RE: ESCR CAG: Asks and requests for clarification re: new park

Thank you for your August 2024 inquiries related to East River Park design. Formal DDC responses are provided below. These responses are in collaboration with Parks and refer to previous responses as appropriate.

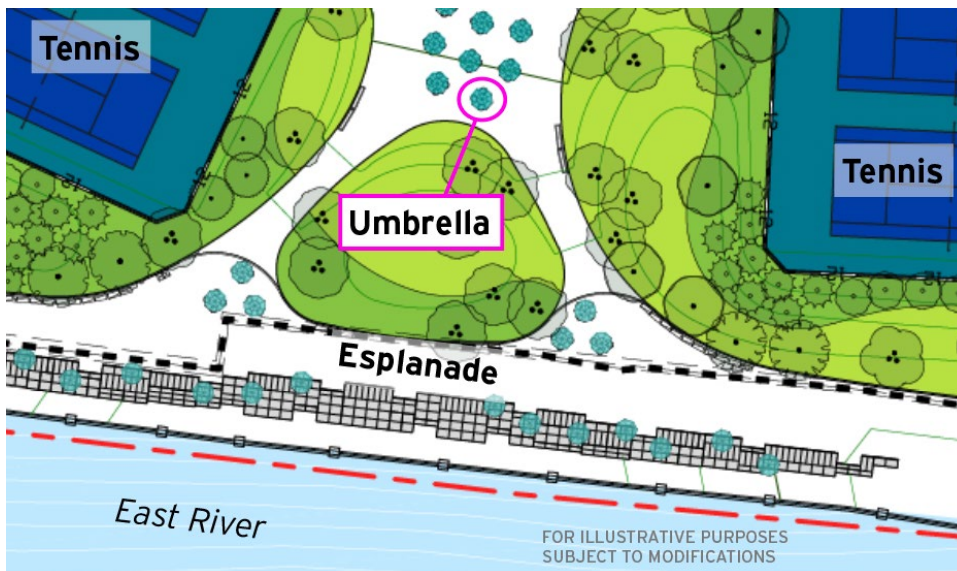
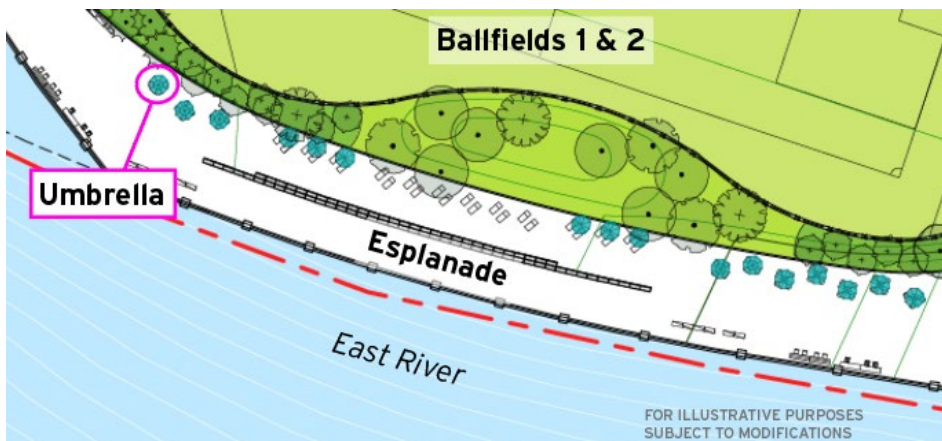
1. From the PDC designs, it looks like the majority of the trees will circle around the fields, courts, and playgrounds, but there will be no more shaded esplanade seating or shaded spectator areas at the ballfields, and shade only around the edges of lawns and picnic areas.¹ If that's incorrect, it would be great for Parks/designers to clarify for us.

2. Is there shaded seating along the esplanade, as there is now, or is all seating in direct sunlight?

DDC Response: *There will be a variety of tree species outside the fencing at ballfields which will grow to offer shade. In the planting areas adjacent to spectator seating at Ballfields 1 & 2, shade tree species include Pin Oak, Willow Oak, Scarlet Oak, Common Hackberry, and Sweet Gum. Species at the western spectator areas of Ballfields 3 & 4 include Swamp White Oak, Sweet Gum, Willow Oak, and London Plane. Smaller lawn areas, like those between the Tennis Courts and Ballfield 3, will also feature shade trees, including Scarlet Oak and Kentucky Coffeetree species. Pin Oak and Willow Oak are among the species surrounding spectator areas at Ballfields 5 & 6. The Track & Field will be surrounded by a diverse array of species, including*

Halka Honeylocust, Northern Catalpa, and Scarlet Oak. The spectator areas at Ballfield 7 are also adjacent to a number of tree plantings. We've highlighted a few key areas here, but there are more species and sizable planting areas throughout the park. As in the current park plantings, trees will line the esplanade in planting beds and grow to provide shade. See illustrations for question 2 below.

DDC Response: *Yes, there are seating areas along the esplanade that include umbrellas. For instance, in the esplanade area directly adjacent to Ballfields 1 & 2, the designs include plans for approximately ten shaded benches and several shaded chaise lounges (see illustration below). In the vicinity of the Tennis Courts, there are nearly thirty umbrellas (see illustration below). There are additional picnic tables with umbrellas near the Nature Exploration area, the BBQ area, immediately north of the Williamsburg Bridge, and near Ballfield 3. On the esplanade closest to the Track & Field, there are more than a dozen umbrellas at tables or chaise lounges. At the northern BBQ area, near E. 10th Street, there are several additional picnic tables with umbrellas.*

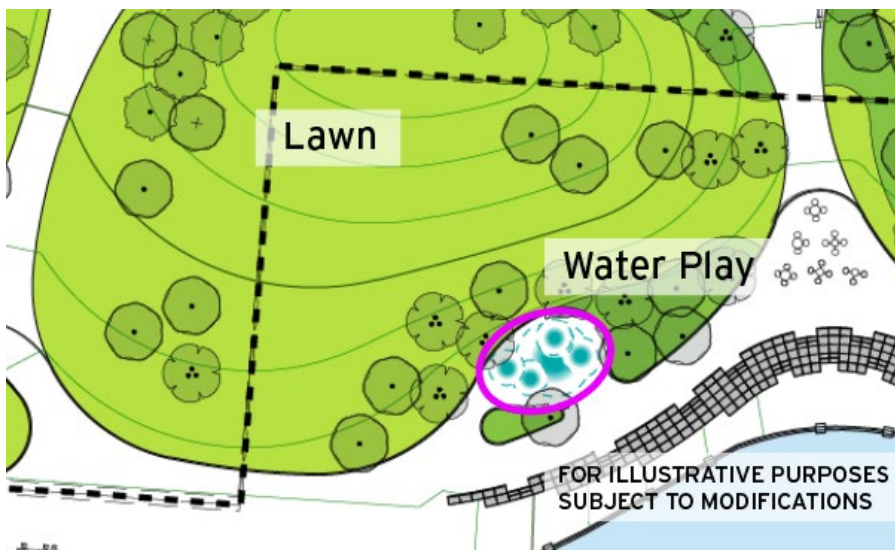
8. How are trees removed from the park being used in the future park, and where?

Parks Response: *The Nature Exploration area is the only location in East River Park where trees from the park are being reused.*

Approximately 30% of the trees in the ESCR project area are slated for salvage, rather than being chipped. Trees suitable for reuse have large diameters with straight stems, high branches, and minimal decay. Salvage tree species are mostly pin oak and London planetree, with some honeylocust, sweetgum, and elm as well. In some cases, more than one log (8-, 10-, or 12-foot in length) will be salvaged from a single tree.

Houston Street

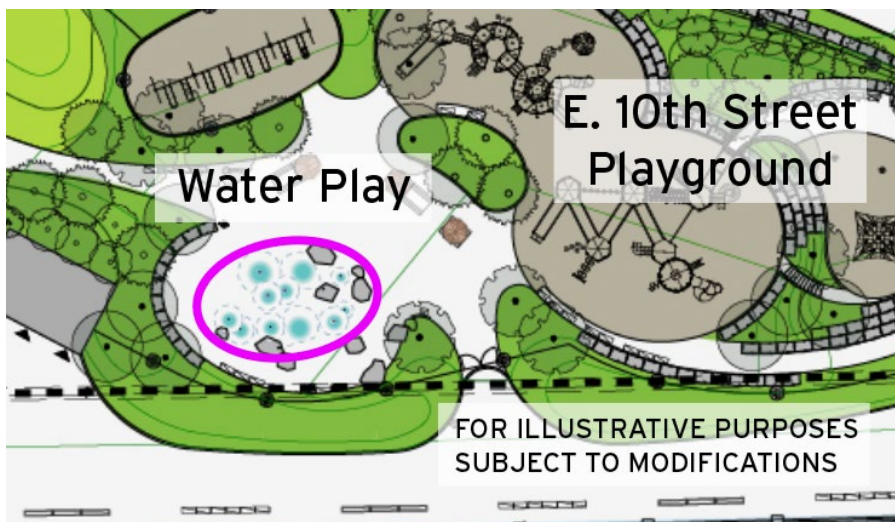
9. What is the square footage of the water play area?

DDC Response: *Accounting only for the water spray features (i.e., not including dry areas like seating), the Delancey Street water play area is approximately 500 square feet, the Houston Street area is approximately 700 square feet, and the E. 10th Street area is approximately 900 square feet. See pink circles in illustrative maps below for the approximate areas measured.*

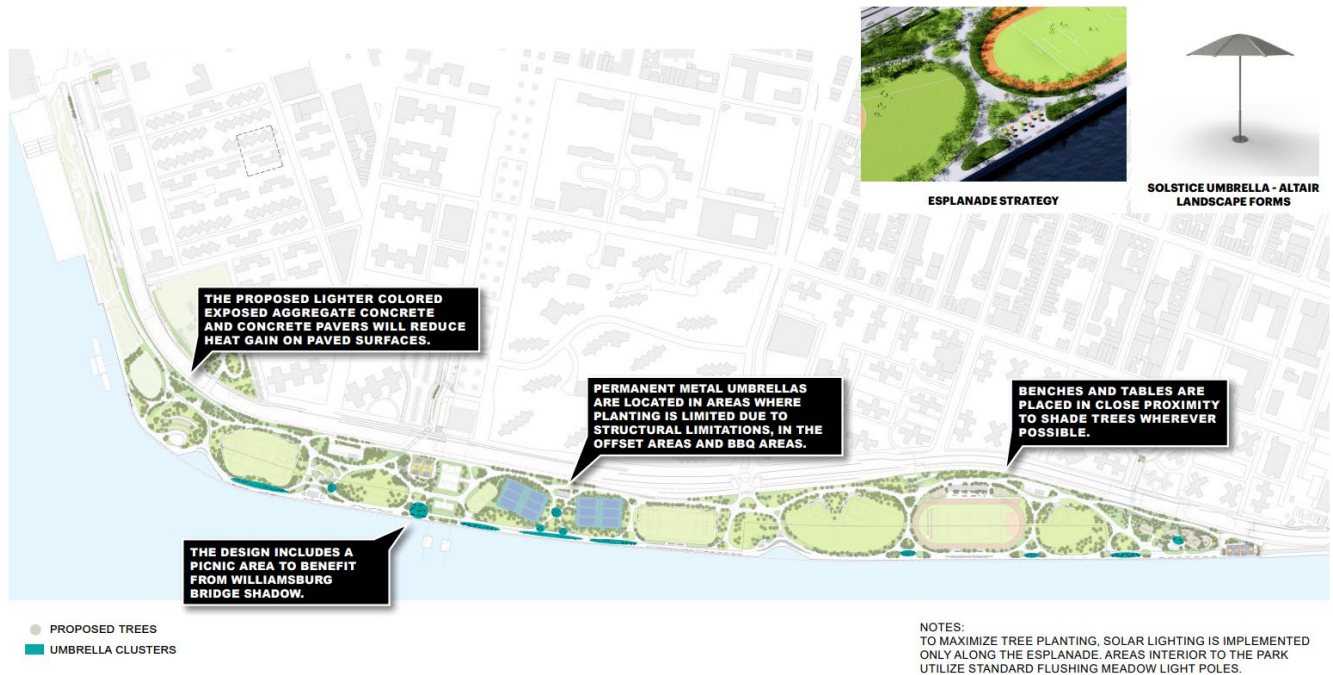
10. Clusters of umbrellas are indicated, but how many are in a cluster?

DDC Response: *These numbers vary, ranging from roughly five to nearly thirty depending on the specific area, as mentioned in Question 2.*
